Docket No. 50-423
B11118

Millstone Nuclear Power Station, Unit No. 3
Transmittal of Responses to Structural Audit Items

The attached responses are provided to close out Items 8, 14, 15, and 25 from the NRC Structural Audit of February 27 through March 2, 1984.

FIG 8-1

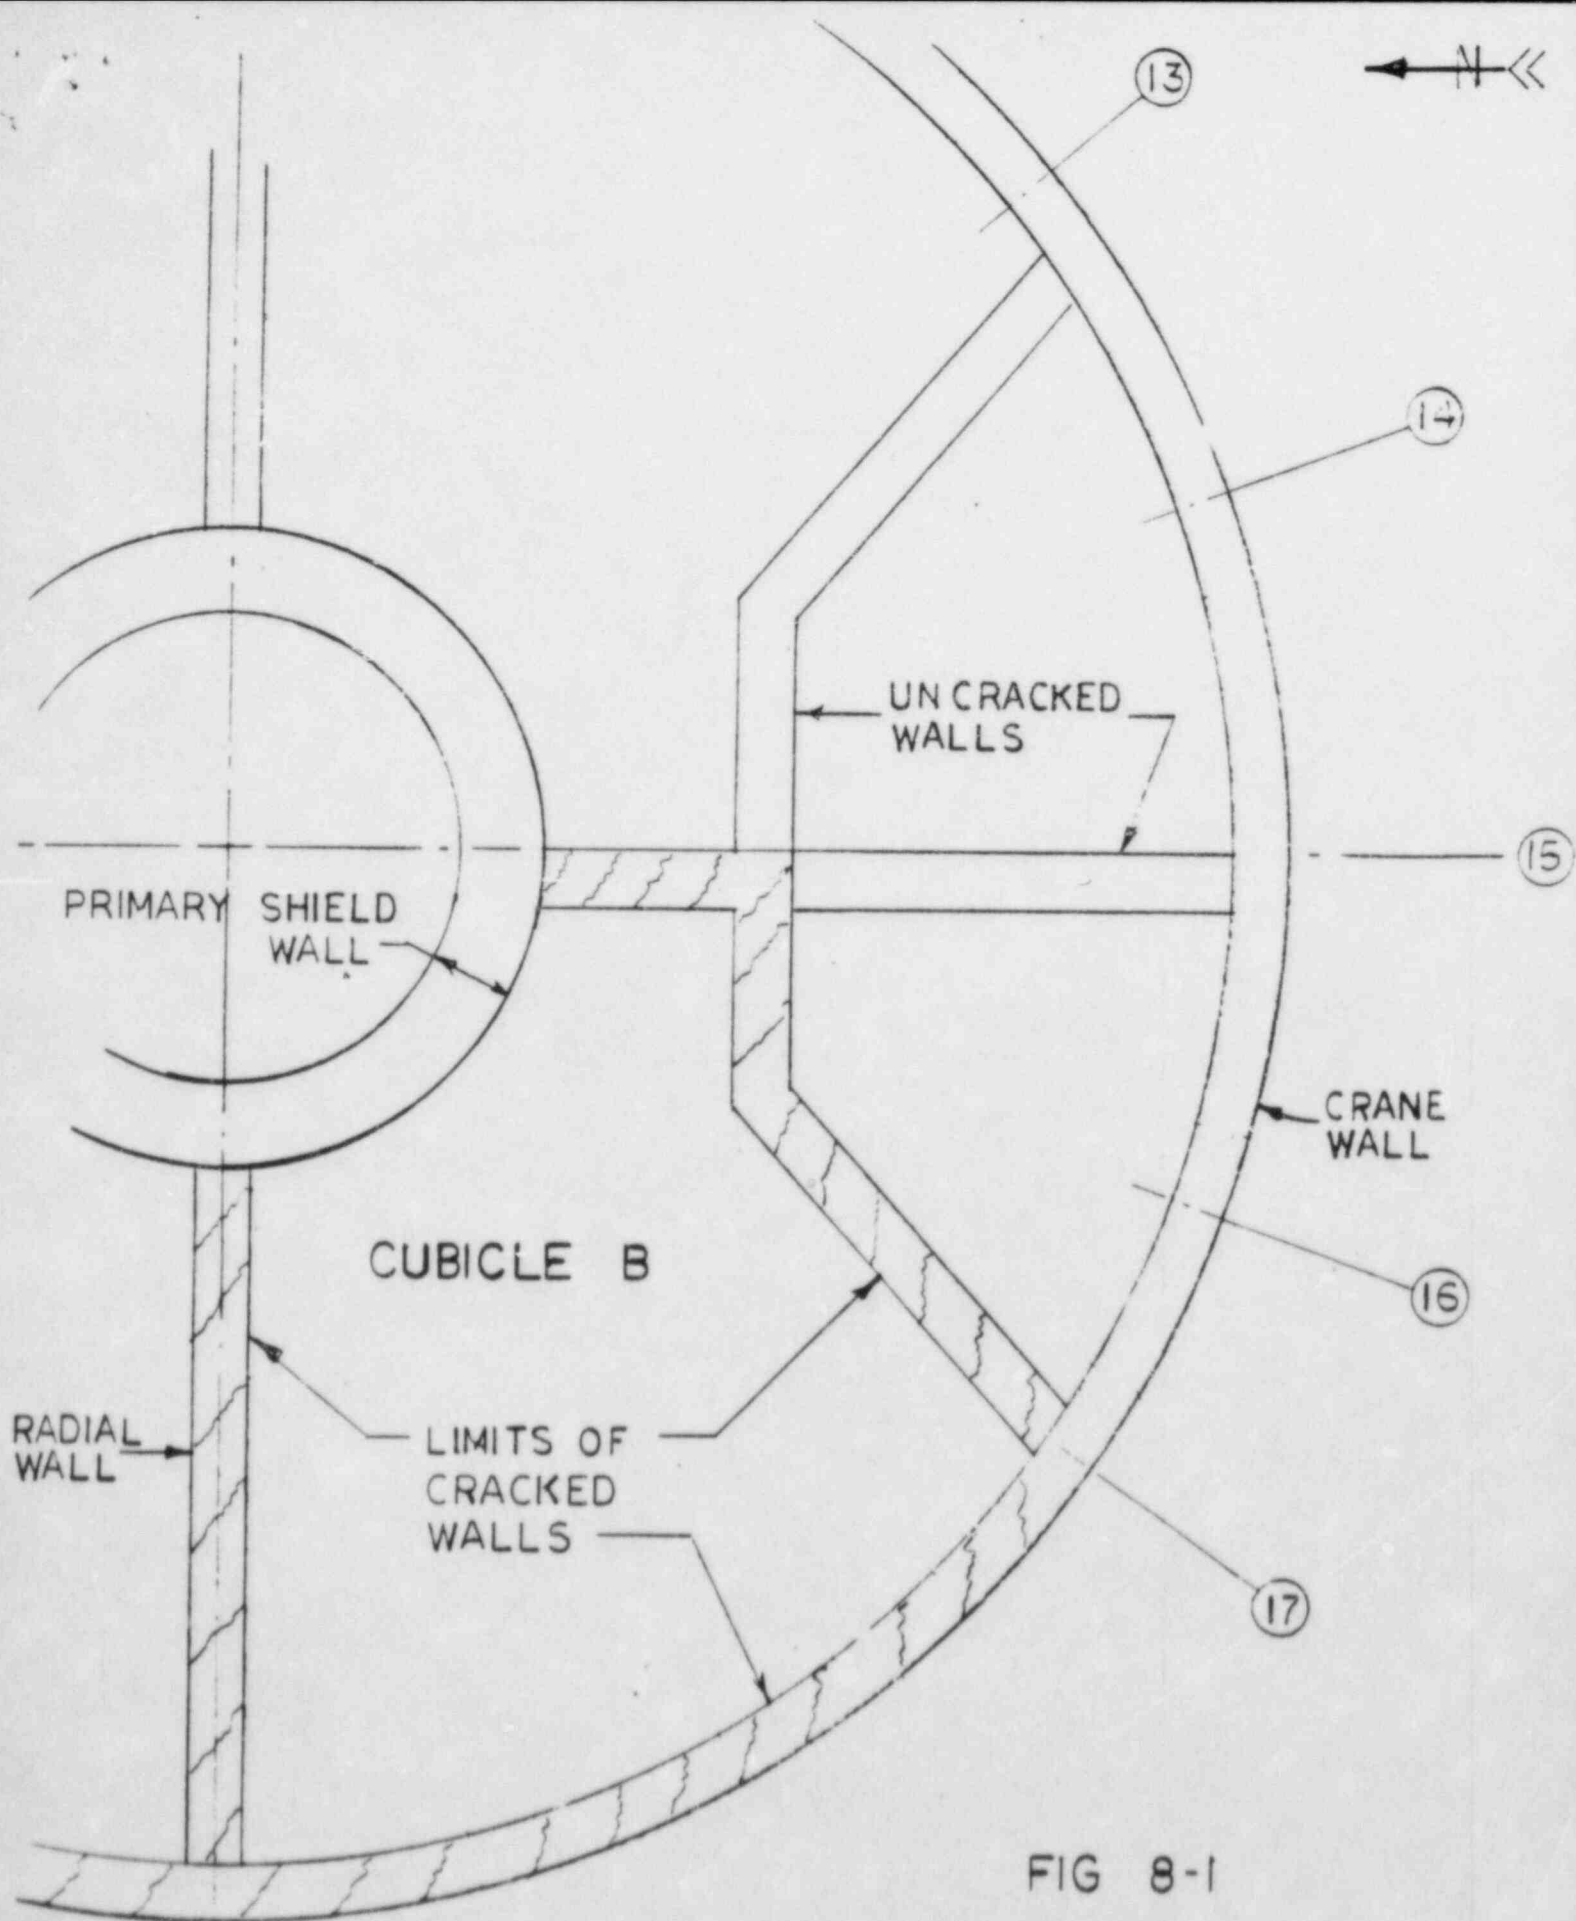
ITEM 8 Provide justification for not considering cracked sections on containment internals in seismic analysis.

In the seismic analysis of the containment structure it was assumed that cracked section properties of the internals will not have any significant change in the overall response of the structure. To verify this assumption another calculation was performed using the cracked section properties of one of the steam generator cubicles. The dynamic model utilized considered the containment exterior wall to be cracked.

Figure 8-1 shows the key plan showing the steam generator cubicle for which the cracked section properties were used.

Figure 1 Relationship between a real member and equivalent member

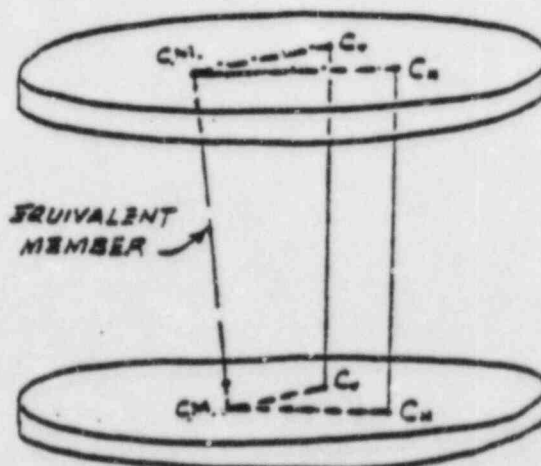
ITEM 14 Provide a detailed discussion on how the CM and CR are considered in development of stiffness matrix. A discussion was presented and the issue was resolved. The Applicant will provide this response.

ITEM 25 Provide a verification example for RIG4 computer program.

An equivalent stiffness matrix is generated to represent the real member (i.e., actual wall section between floors) spanning from center of mass of the lower floor to upper floor, considering both the vertical as well as the horizontal center of rigidity as shown on Figure 1. It is assumed that a rigid link connects the center of mass to the center of rigidity of the real member (i.e., C_V and C_H). A principal global stiffness matrix is then developed, considering bending and shear deformations of the wall section by applying unit displacement and rotations at the center of mass and determining the corresponding stiffness terms that result (see Figure 2). As an example, for a unit displacement in the X_p degree of freedom, the resulting stiffness terms are shown on Figure 2a. Similarly, unit displacements and rotations are applied in the remaining degrees of freedom resulting in the principal global stiffness matrix as given in Table 1. This resulting matrix is then rotated about the Y_p axis (Figure 3) through an angle β between principal axis of the wall section and global axis as defined by the mathematical model (i.e. N-S axis and E-W axis generally define the global axis system of the building model). This resulting matrix is then rotated about the Y_g axis and Z' axis as indicated in Figure 4 to obtain the equivalent local stiffness matrix of the real member.

FIGURE 15-1

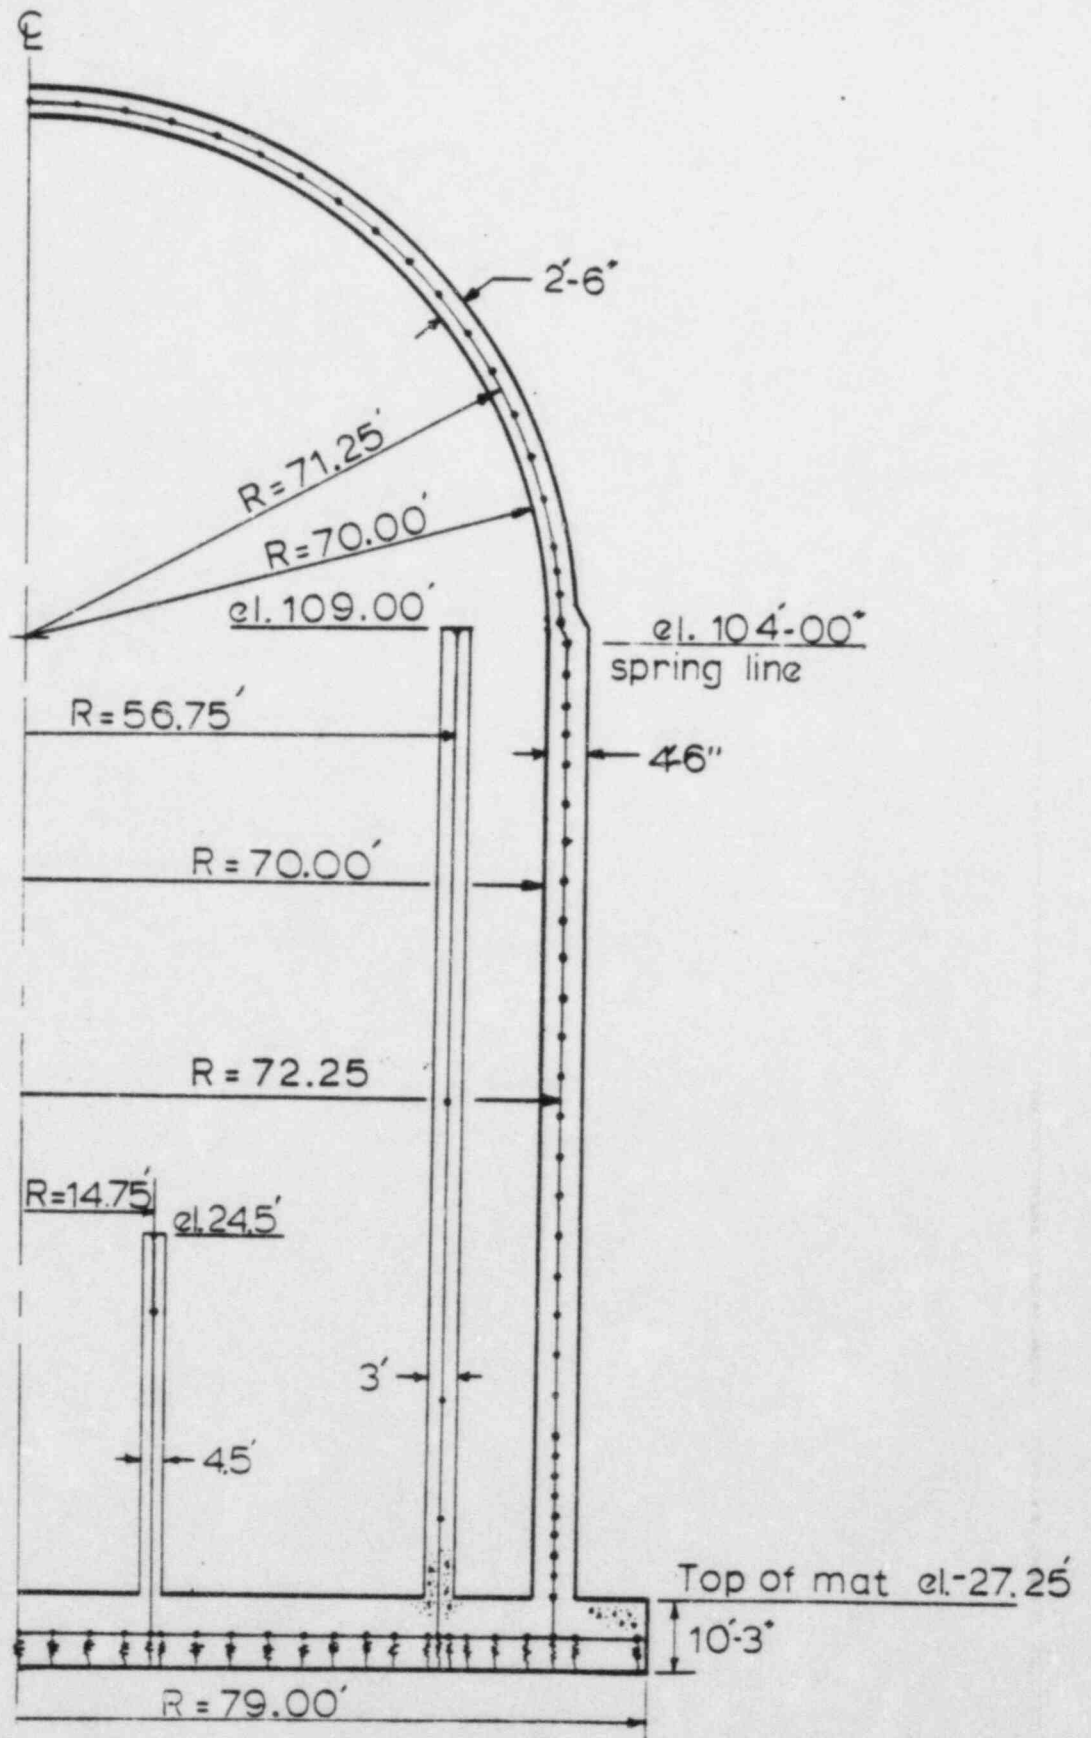
- (iii) Review the basic shell/mat junction and demonstrate that compressive failure modes were adequately considered.

Figure 15-1 - Containment structure showing the critical Sections C_1 to C_5 and B_1 to B_3 .

From the results of the finite element analysis, the axial force and bending moment as a function of internal pressure were determined for Sections B₁ and C₁, at the cylinder wall mat junction of the containment (see Figure 15-1). These sections were then evaluated for the axial forces and bending moments. The resulting liner, reinforcement, and concrete stresses and strains are presented in Tables 15-3 and 15-4. It is evident from a review of these tables that total yielding of all reinforcement occurs before a max concrete strain of 0.003 is achieved for both sections thus demonstrating that full capacity of the section is achieved prior to any compressive failure of the concrete.

FIGURE 15-2

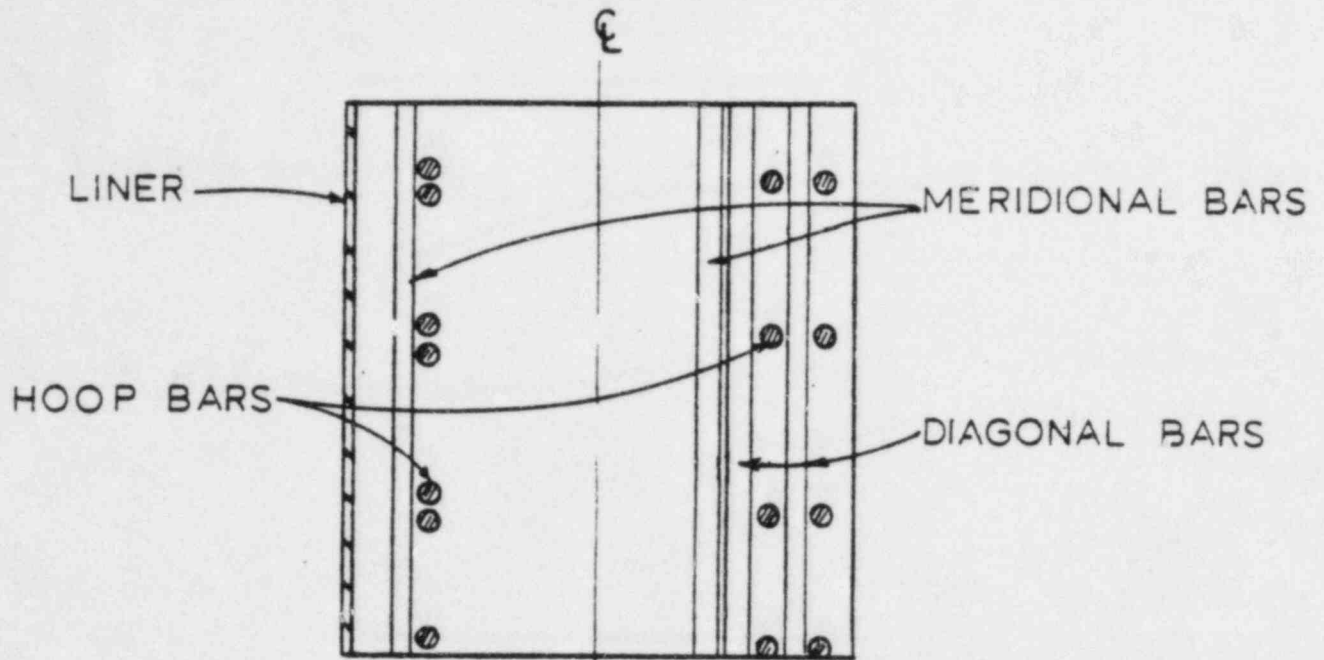
- (i) Were elements that yielded prior to final yielding continuously checked to ensure that they were within acceptable ductility limits?

Figure 15-2 - Represents the model showing the centerline dimensions and nodes.
